RIZZO ASSOCIATES, INC.

October 16, 1989

RE: Comments on "Draft Final Hot Spot Feasibility Study
New Bedford Harbor July 1989"

FIGURE 3-1

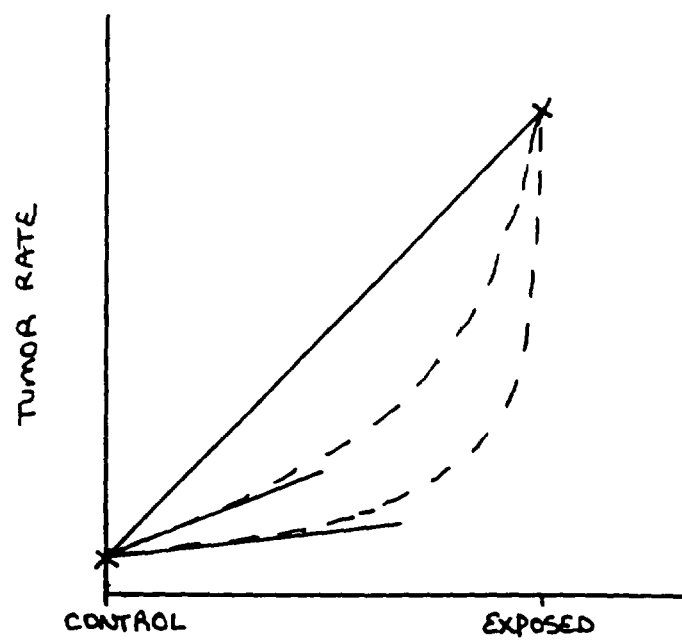
There is a great deal of uncertainty associated with a cancer potency estimate based on a single data point in addition to controls. As Figure 3.1 shows, the degree of curvature is unknown in such a situation and can vary significantly, affecting the slope at low doses and therefore the estimate of potency by many orders of magnitude.

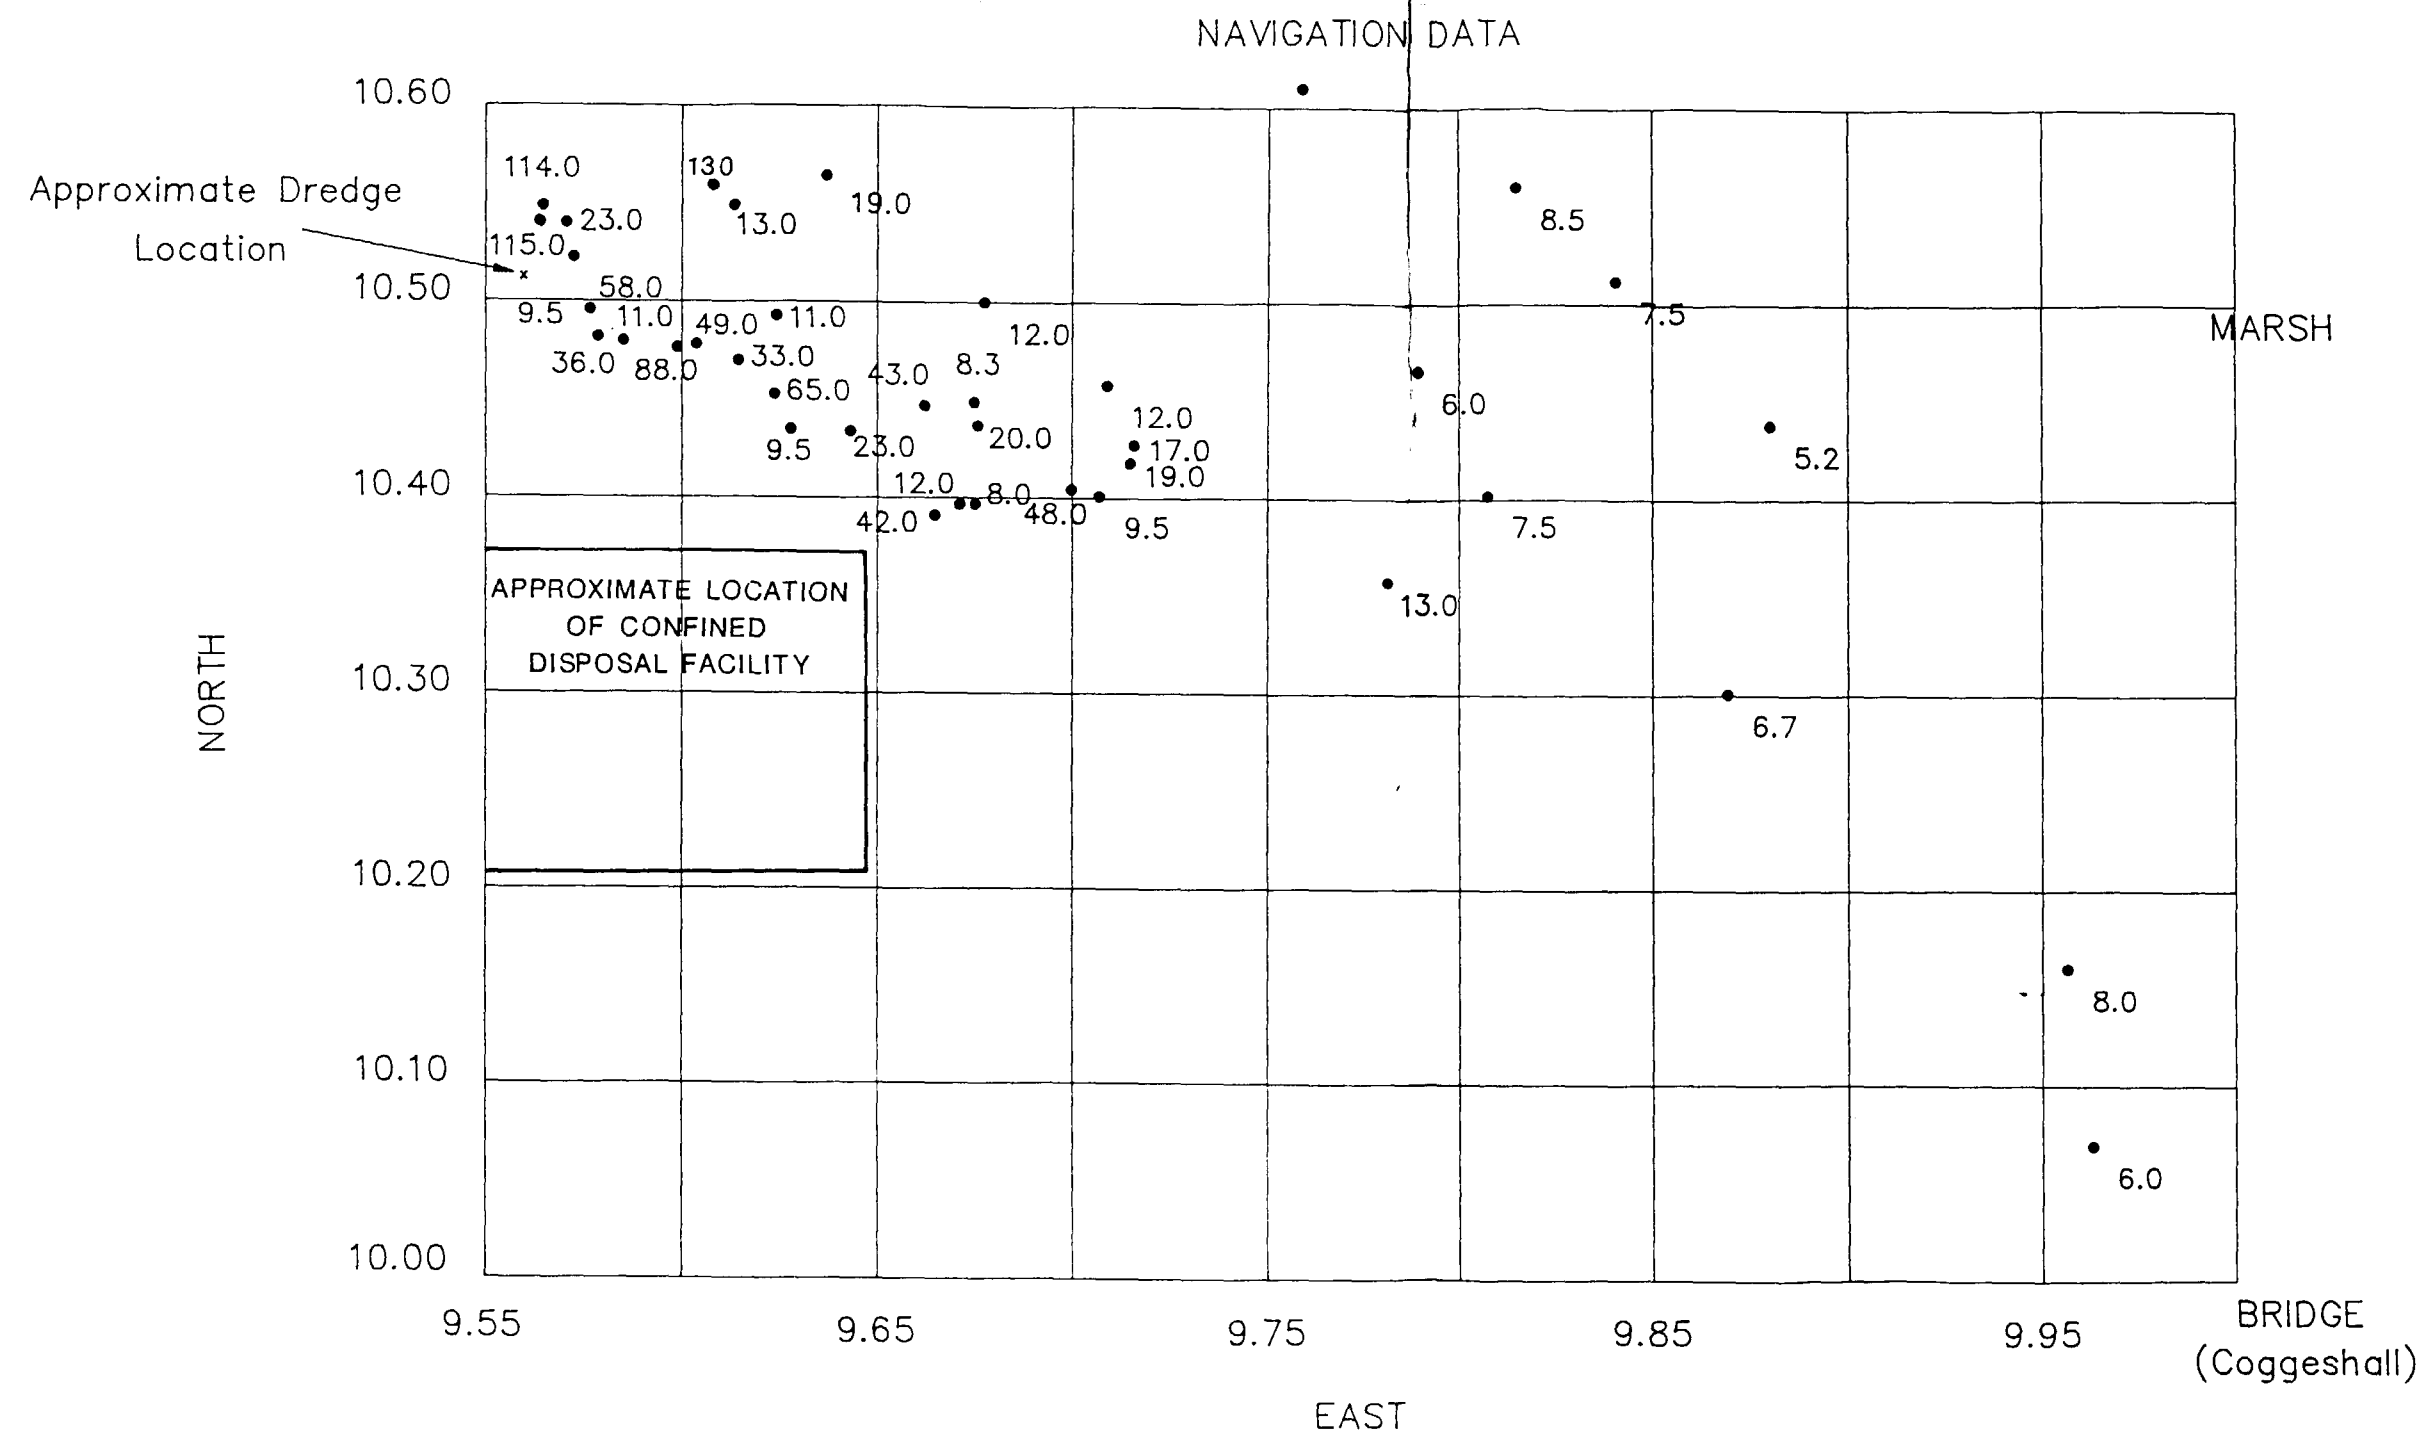
The turbidity and aerial photography data collected during the pilot study clearly indicate that there was significant resuspension in the pilot cove during the pilot program. Such resuspension impacts would likely be magnified for dredging undertaken in the "hot spot" area.

EPA has planned "hot spot" dredging production rates at 75 percent above the rate documented by the Corps during the pilot study. However, they predict that the sediment resuspension rate at that production rate will be less than

the mean value observed by the Corps at the lower rate. It is likely that higher production rates will result in higher resuspension. The government has certainly underestimated the resuspension rate that will occur in practice if the program is implemented as they plan.

NEW BEDFORD HARBOR WATER QUALITY STUDY SEDIMENT PLUME MONITORING USING TURBIDITY

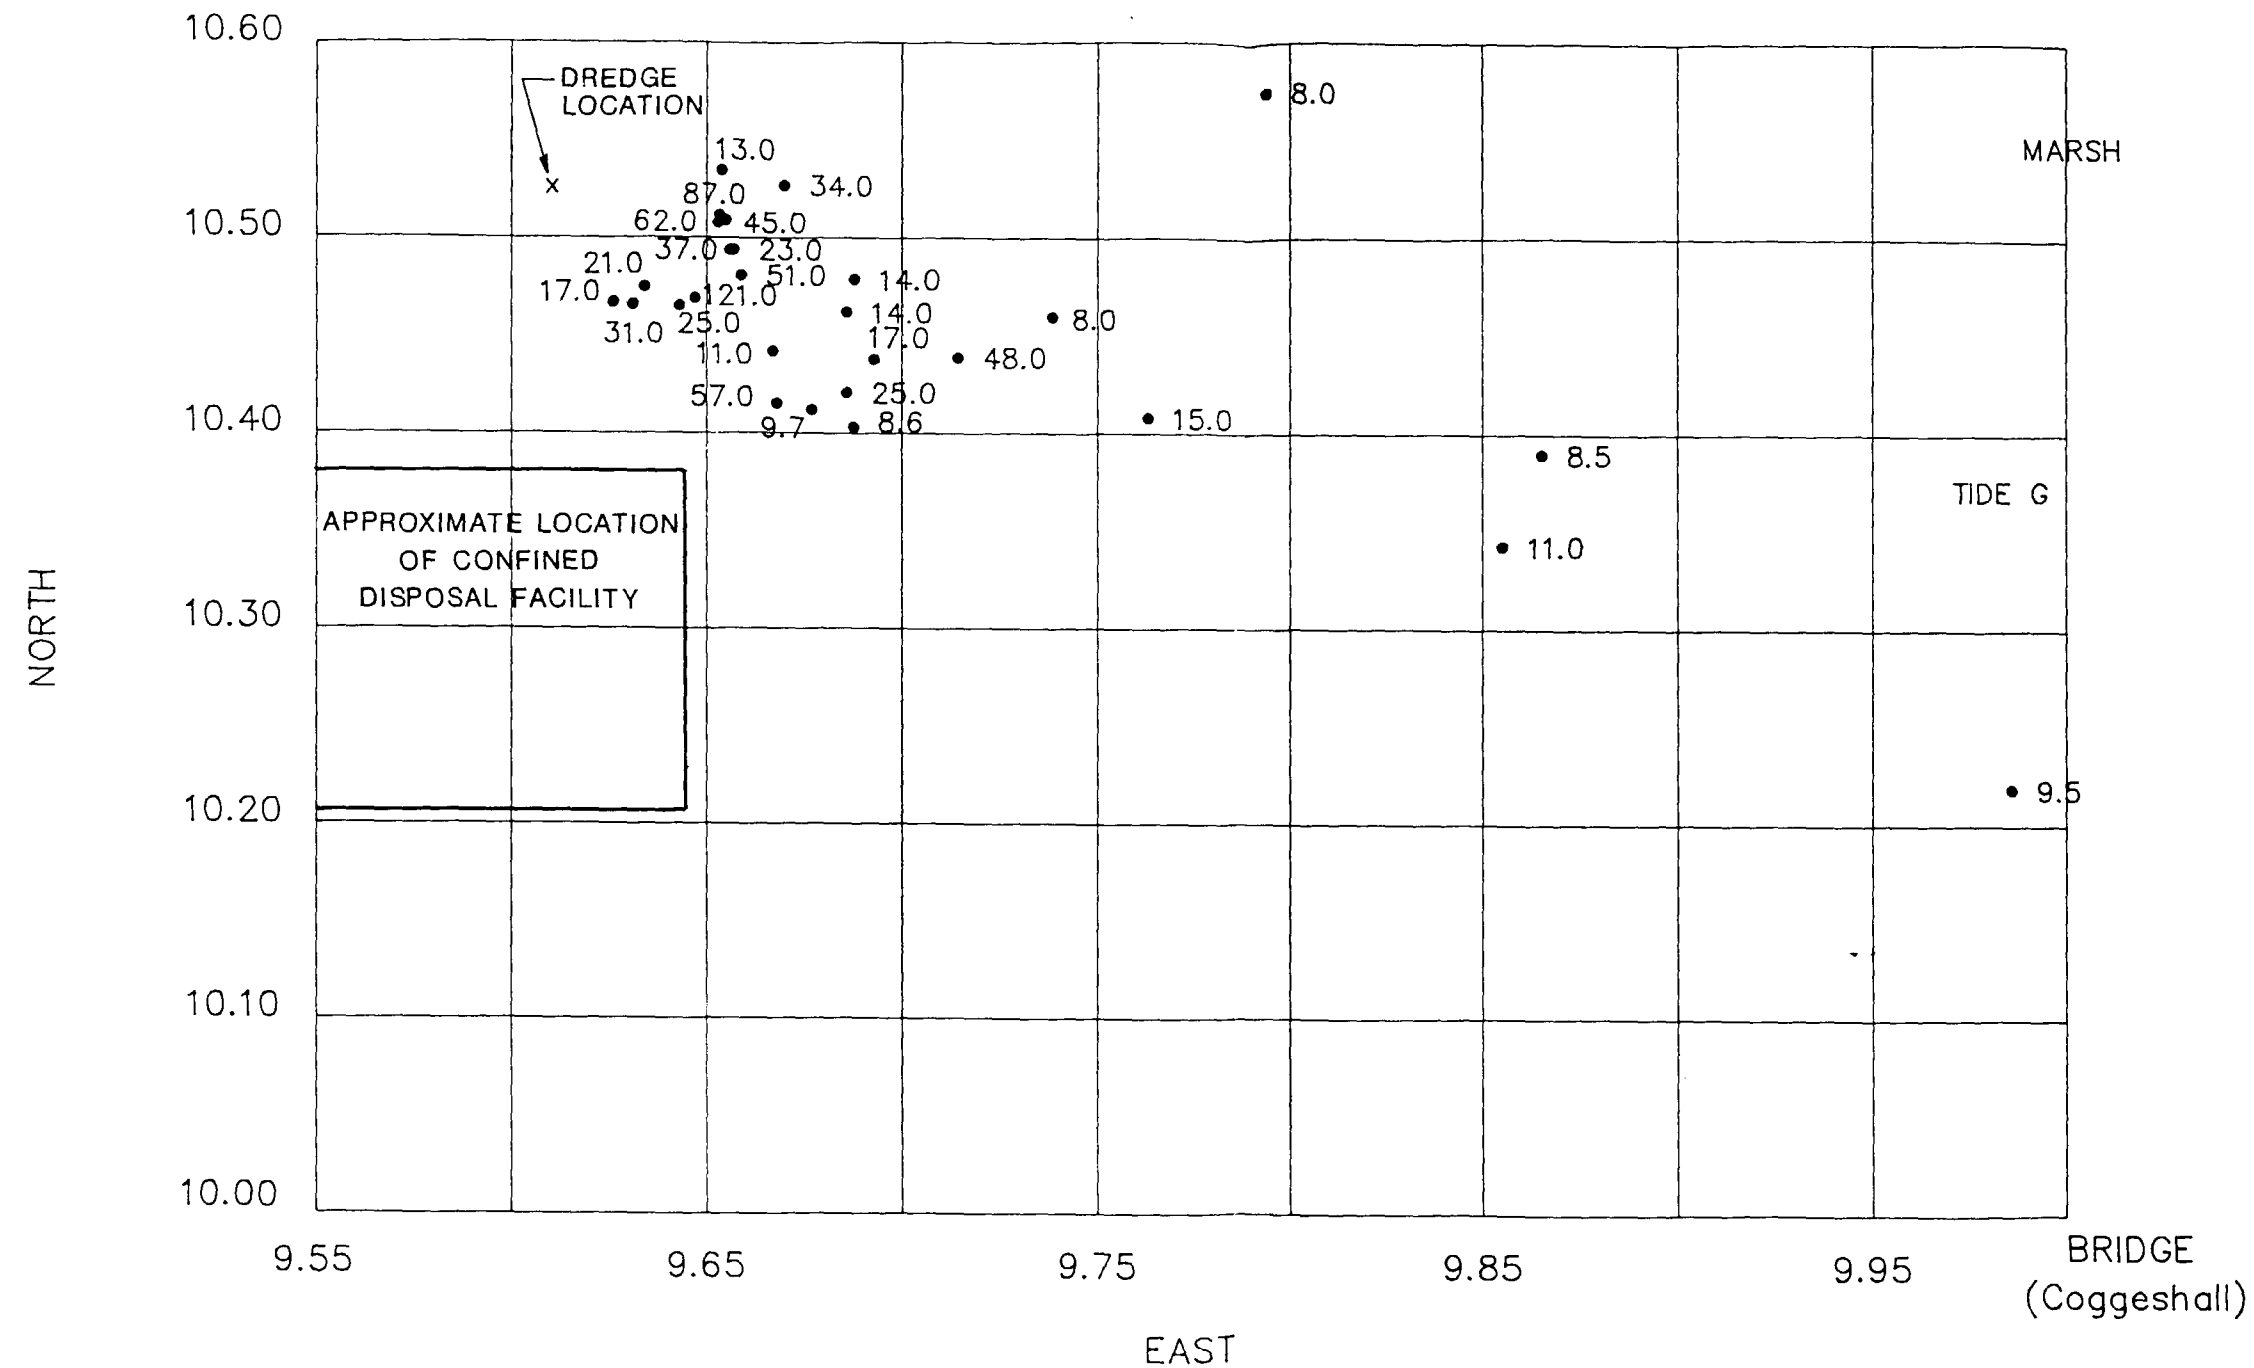
Turbidity monitoring conducted within approximately 100 to 700 feet of the active dredges was performed on December 22, 1988 and January 13, 1989 from a small boat. The Matchbox and Cutterhead dredges were operating during these two data collection events. Turbidity measurements in December 1988 ranged between 5.2 and 130 NTU, and had a mean response of 34 NTU. The January sampling data yielded turbidity measurements between 8.0 and 121 NTU with a mean value of 36 NTU.

program, however, indicate that there was significant resuspension and a plume of sediment existed not only at the dredgehead but for some distance away from the dredge. Therefore, the complete data set must be evaluated in detail.
